## **ADDENDUM NO. 2**

- A. Date: 22 March 2012
- B. From: Bahr, Vermeer and Haecker Architects, Ltd.
- C. To: Prospective Bidders.
- D. Project: Wilber-Clatonia High School Ceiling Remodel  
Wilber, Nebraska
- E. This addendum is issued by the Architect to all bidders of record prior to receipt of proposals. Bidders shall acknowledge receipt of this addendum by so indicating on the Bid Form. Failure to do so may subject Bidder to disqualification.
- F. All information and instructions given herein shall become a part of the Contract Documents.
- G. This Addendum contains 3 total pages with 7 attachments.

**Wilber-Clatonia  
High School  
Ceiling Remodel**

03/21/12
SHEET
<b>M2.1</b>
ATTACHMENT NO.
1
B/AF

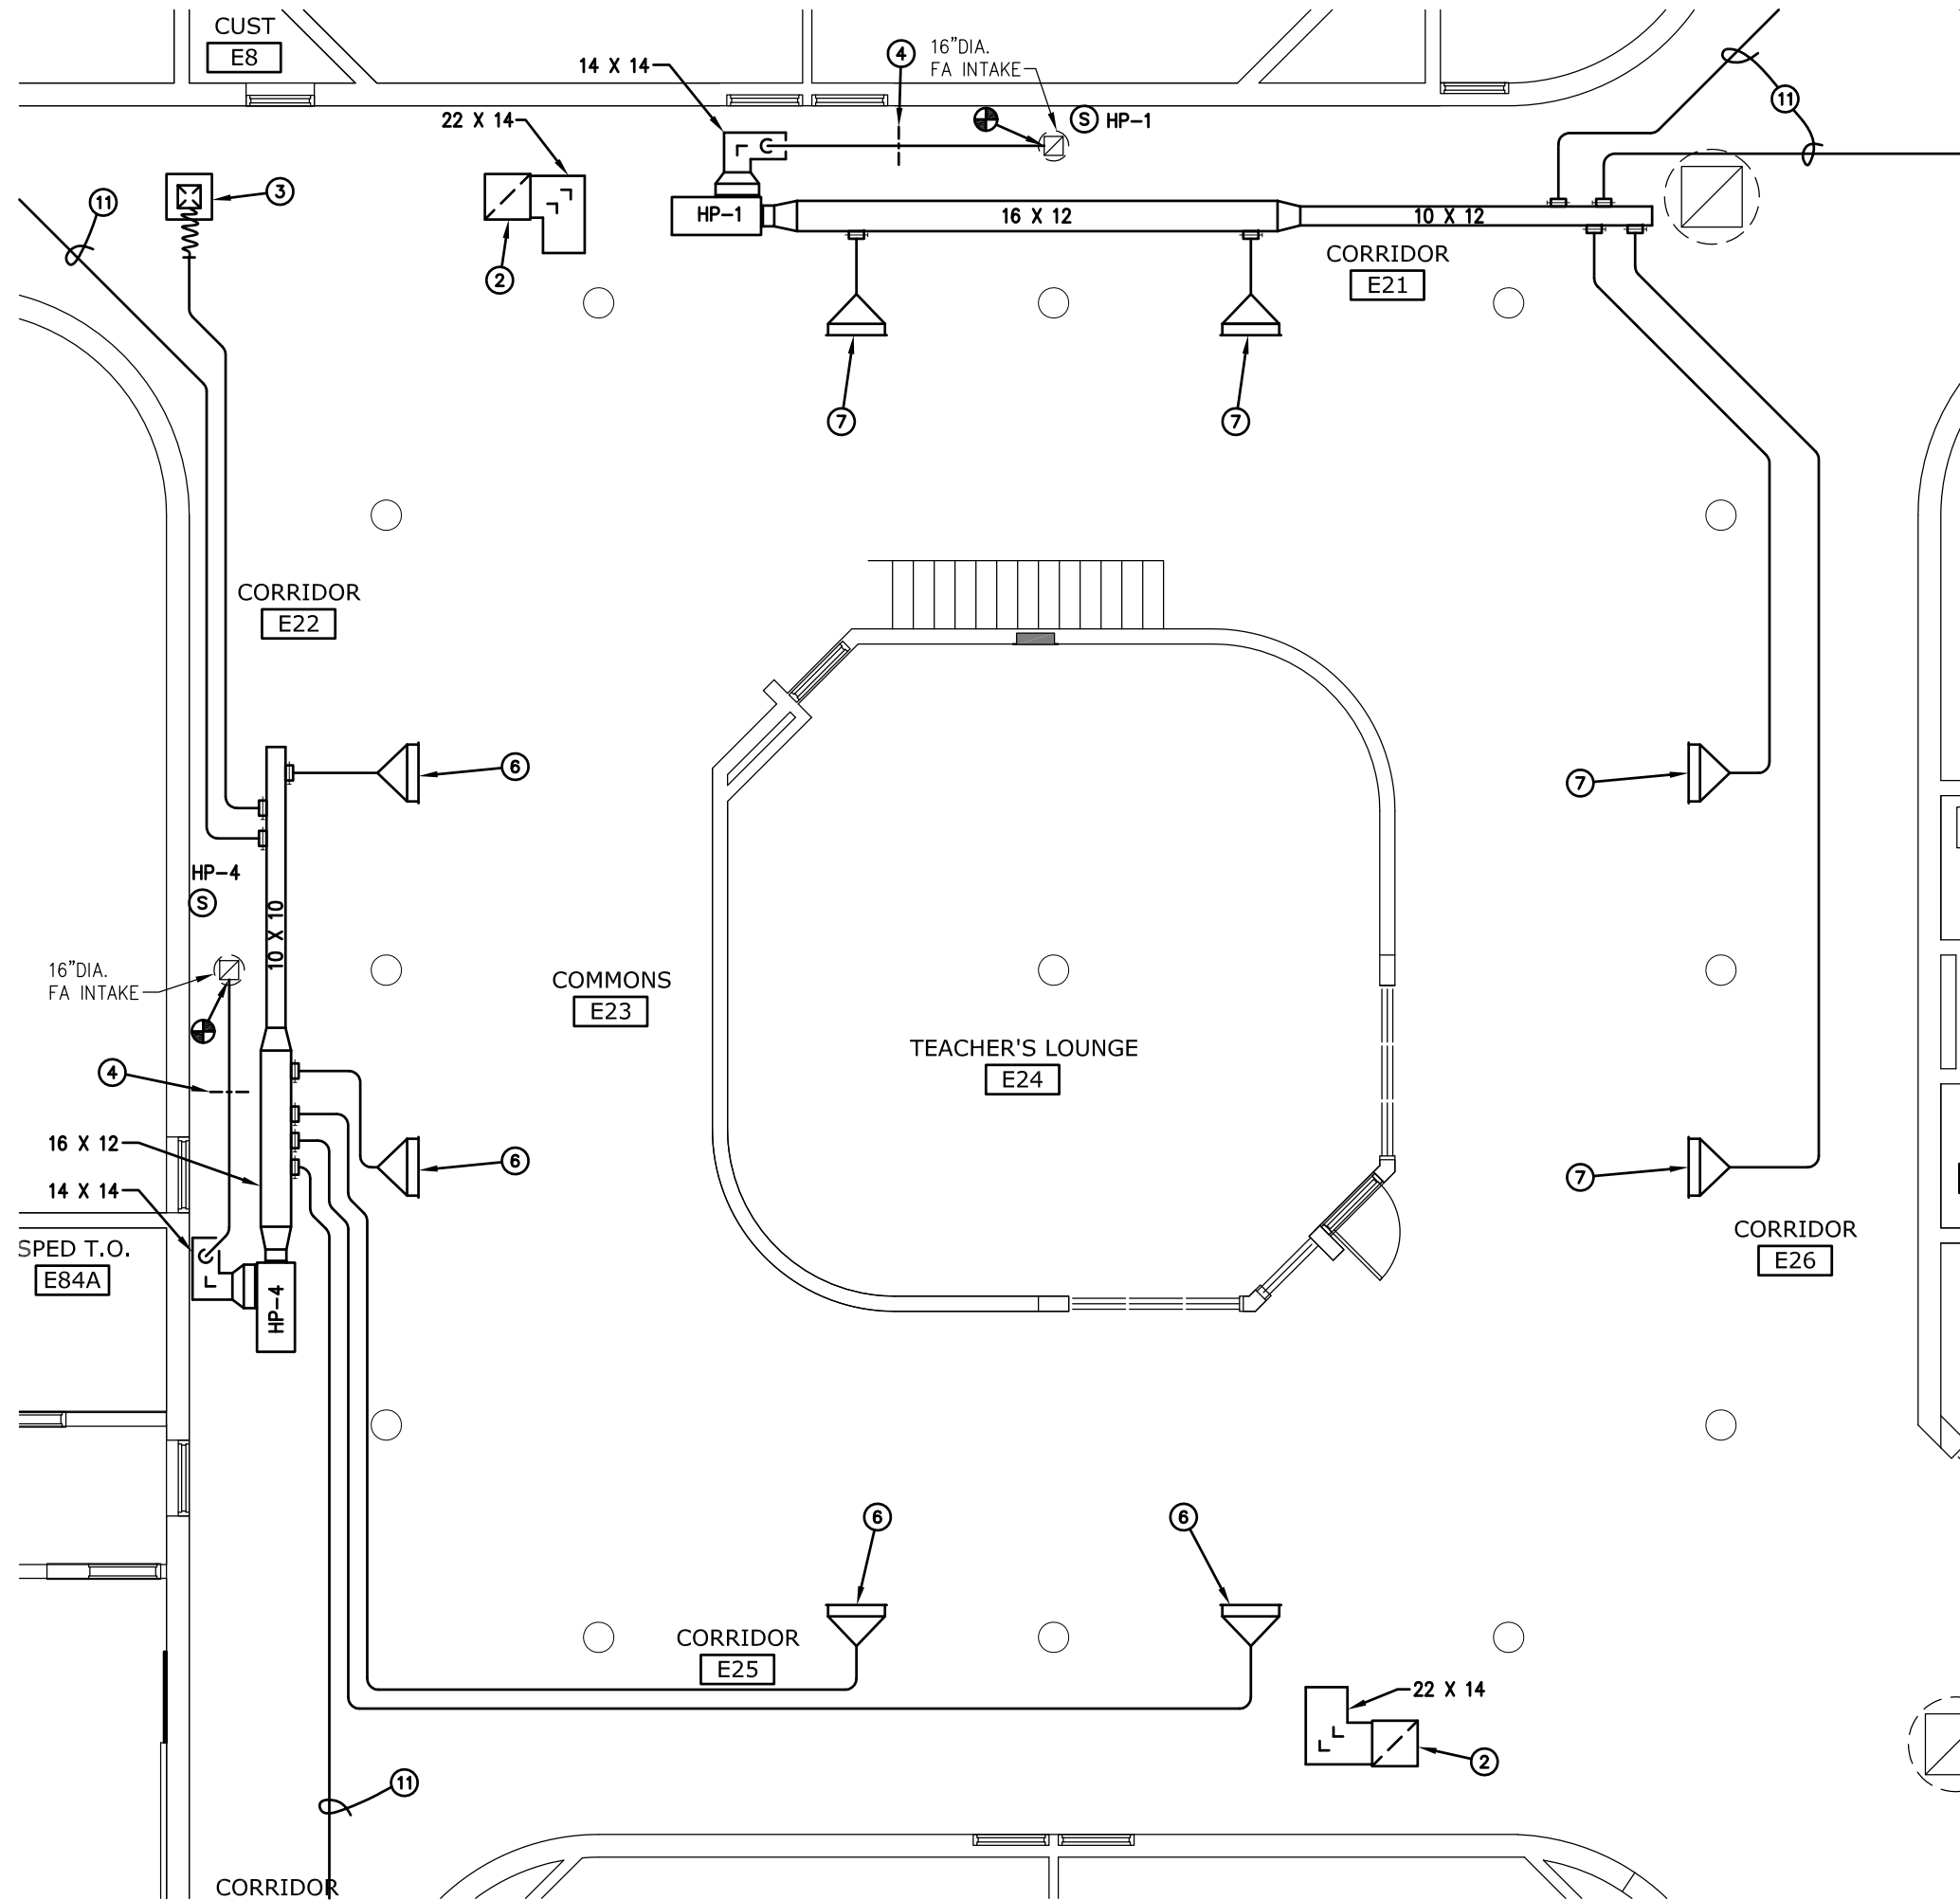
- A. Sheet M1.1 First Floor Demolition Plan
1. Fresh air hood on UV #15 & #16 to be removed. Cap existing curb, support cap and fill with fiberglass insulation as required. See Existing Curb Cap Detail on sheet A3.1 for requirements.
- B. Sheet M2.1 First Floor Mechanical Plan
1. Heat pump piping changes. See drawing M2.1 attachment 1.
  2. Along west wall of Vestibule 19, from Classroom E18D to Janitors E67, remove and provide new Deco Shield to cover existing fire sprinkler piping as required. Color to match existing cover.
- C. Sheet M3.1 First Floor HVAC Plan
1. Ductwork changes and deletion of HP-2 and HP-3. See drawing M3.1 attachment 1.
- D. Sheet E4.1 Heat Pump Schedule
1. Delete HP-2 and HP-3 from Schedule.
  2. The following manufacturers have received prior approval for bidding purposes subject to shop drawing review:
    - a. Heat Pumps Trane

03/21/12
SHEET
M3.1
ATTACHMENT NO.
1
B/AF

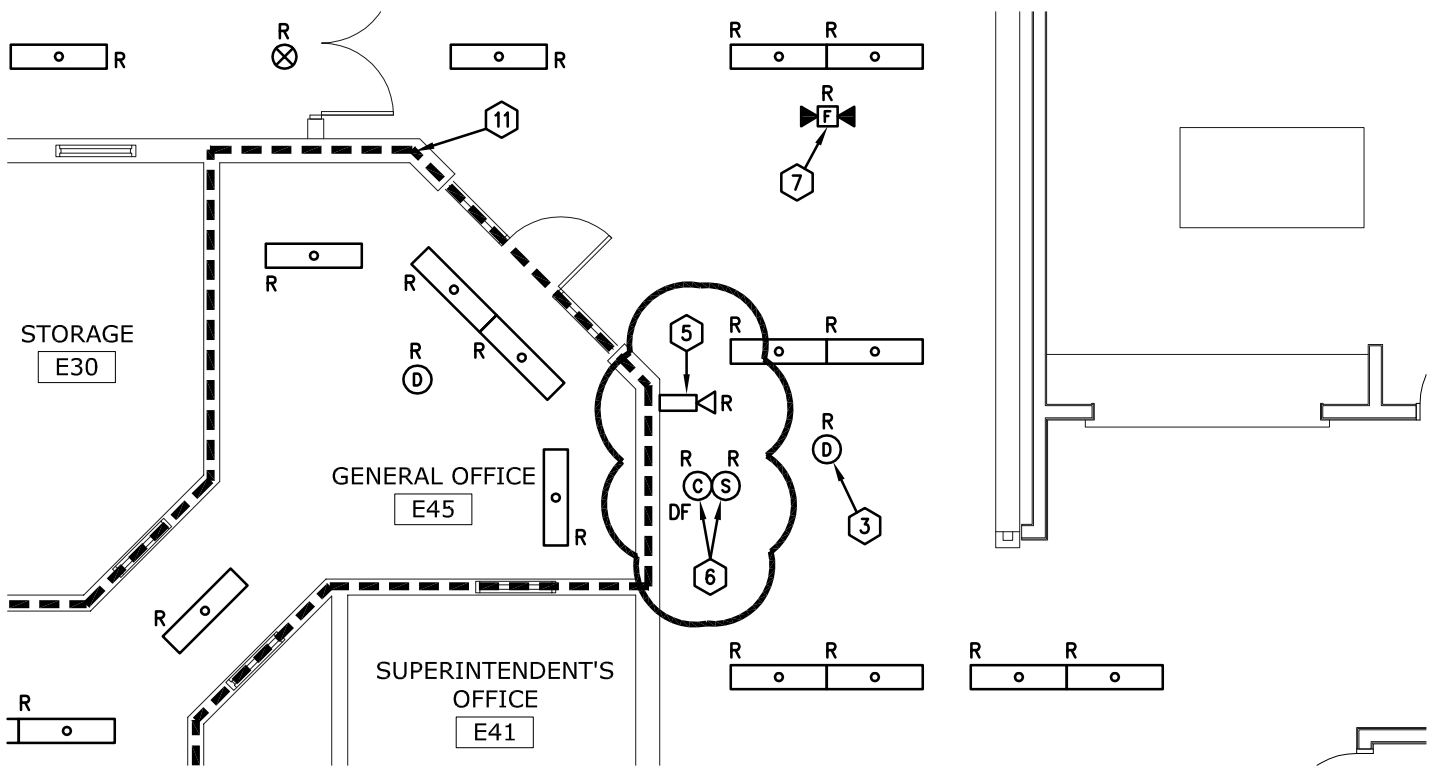
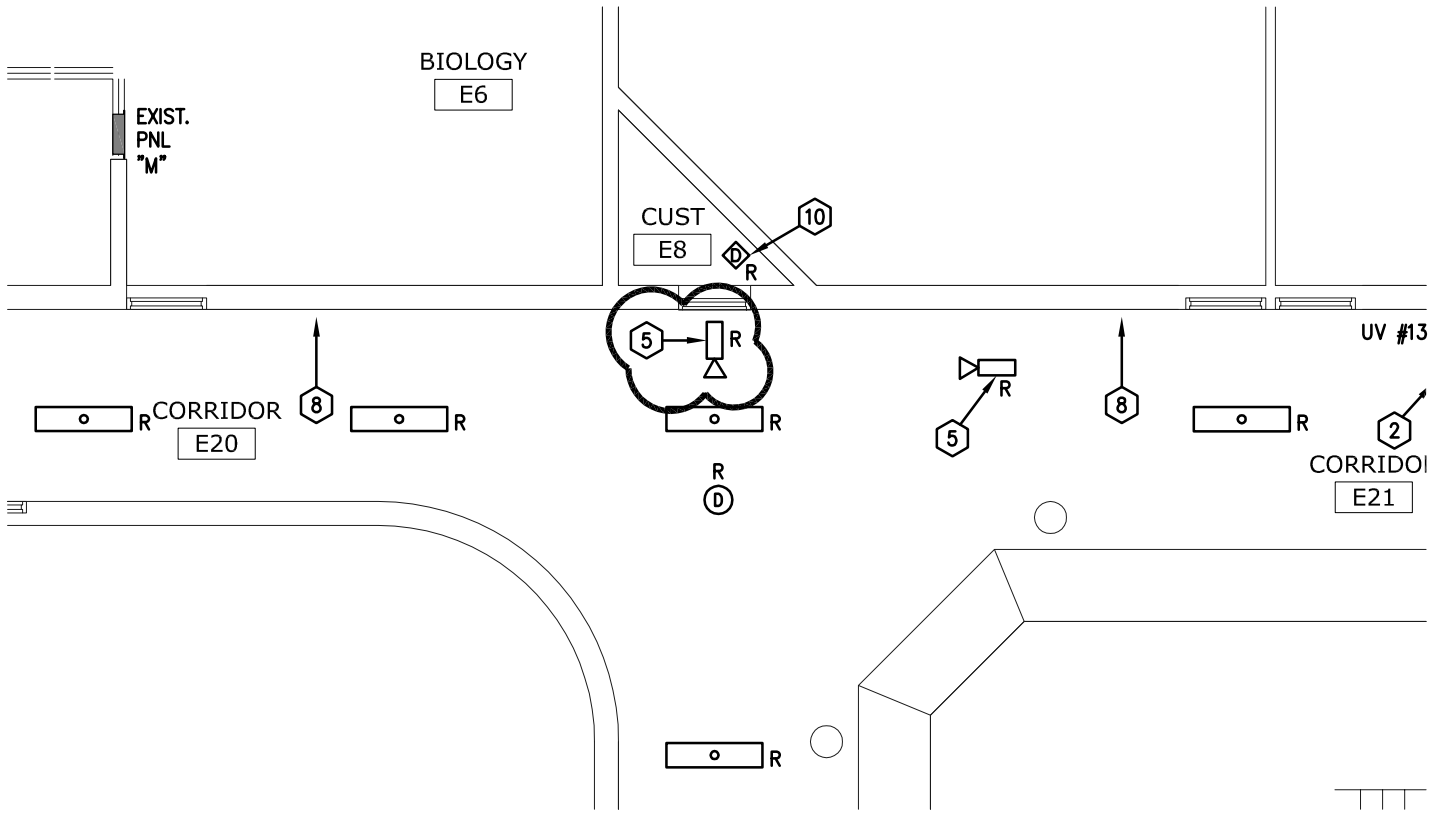
- # SHEET NOTES**
- 10" DIA. CD-1, WITH 410 CFM. EXTEND 10" DIA. DUCT TO REGAIN BOX. SEE REGAIN BOX DETAIL ON SHEET M4.1.
  - 22 X 22 RA-1.
  - 6" DIA. CD-1, WITH 100 CFM. EXTEND 6" DIA. DUCT TO REGAIN BOX. SEE REGAIN BOX DETAIL ON SHEET M4.1.

- PROVIDE 7" DIA. MOTORIZED DAMPER IN 7" DIA. FRESH AIR DUCTWORK. BALANCE FRESH AIR TO 135 CFM.
  - PROVIDE 9" DIA. MOTORIZED DAMPER IN 9" DIA. FRESH AIR DUCTWORK. BALANCE FRESH AIR TO 300 CFM.

- 30" LINEAR DIFFUSER LD-1, WITH 175 CFM. EXTEND 7" DIA. DUCT TO DIFFUSER PLENUM.
  - 30" LINEAR DIFFUSER LD-1, WITH 200 CFM. EXTEND 8" DIA. DUCT TO DIFFUSER PLENUM.

- UNDER ALTERNATE #1, EXISTING DIFFUSERS AND GRILLES SHALL BE SUPPORTED DURING DEMOLITION OF EXISTING GYPBOARD CEILING AND RELOCATED INTO NEW LAY-IN CEILING AS REQUIRED. EXTEND OR MODIFY DUCTWORK AS REQUIRED.

- REBALANCE EXISTING FLOOR DIFFUSER TO 325 CFM.
  - MODIFY EXISTING DUCTWORK AND CONNECT TO NEW HEAT PUMP.
  - EXTEND 6" DIA. DUCTWORK TO 6" DIA CD-1 IN CORRIDOR.

WILBER-CLATONIA HIGH SCHOOL  
 CEILING REMODEL  
 PARTIAL FIRST FLOOR ELECTRICAL  
 DEMOLITION PLANS

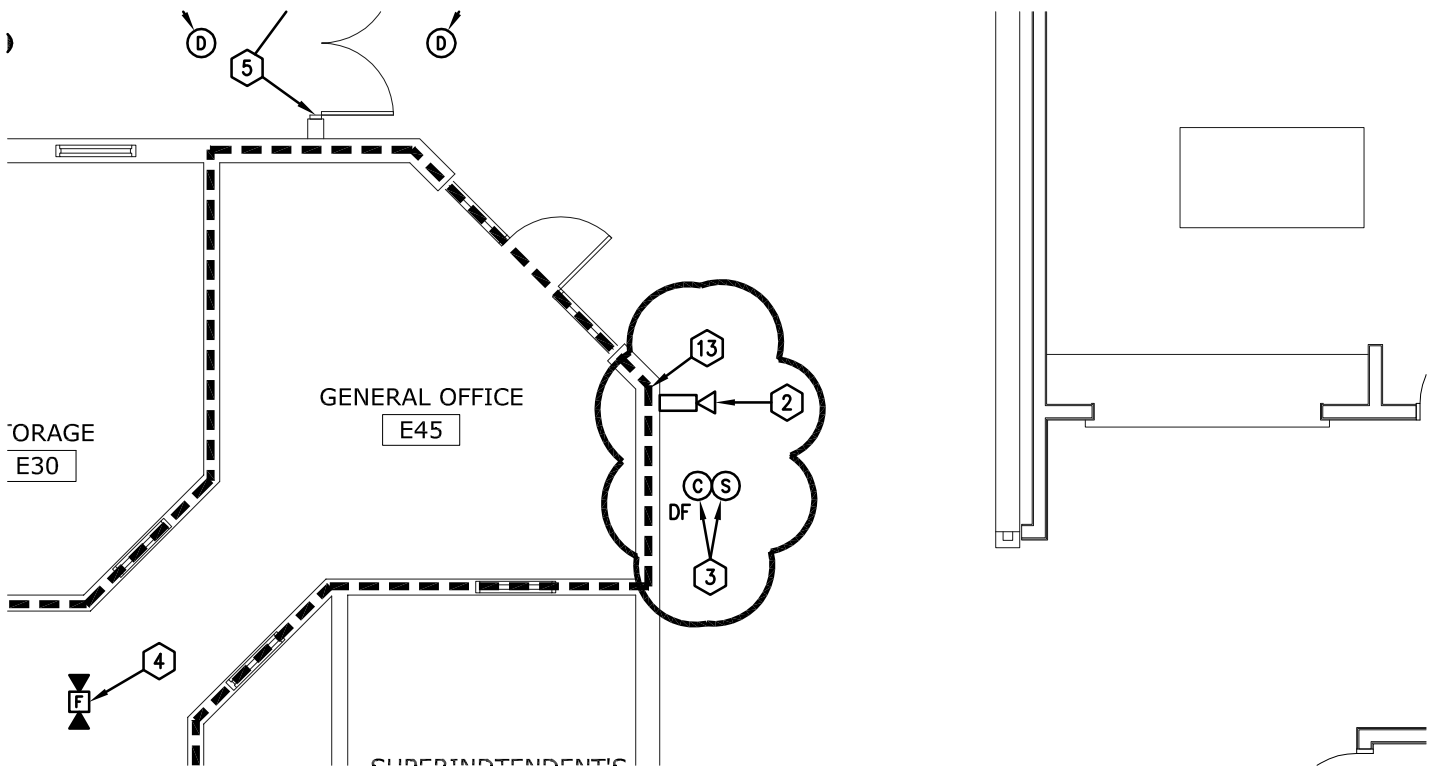
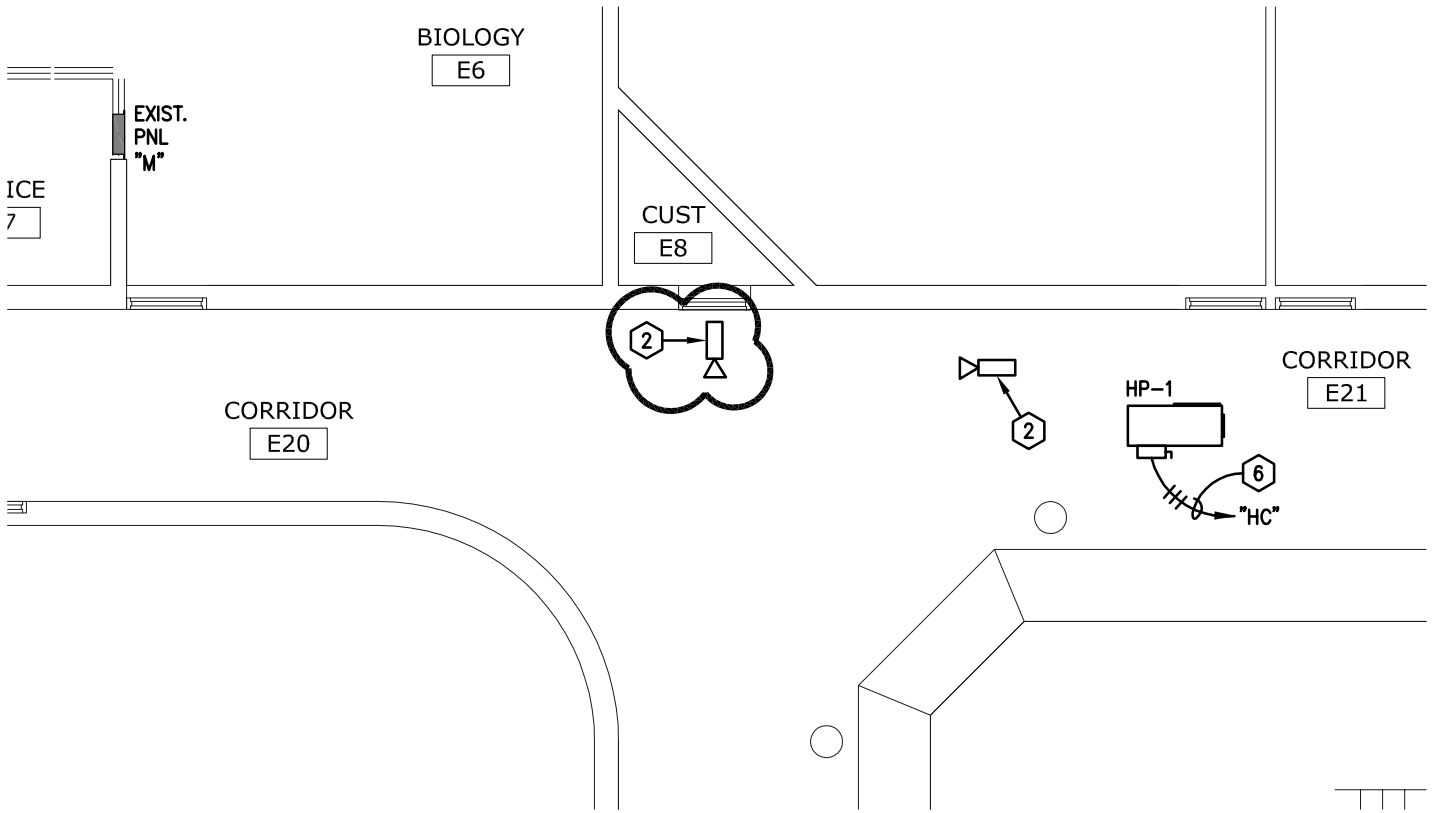
- A. Sheet E1.1 First Floor Electrical Demolition Plans
1. Reference attachment E1 for two (2) additional locations of cameras and one (1) additional location of a combination clock/speaker that are to be relocated to new ceiling.
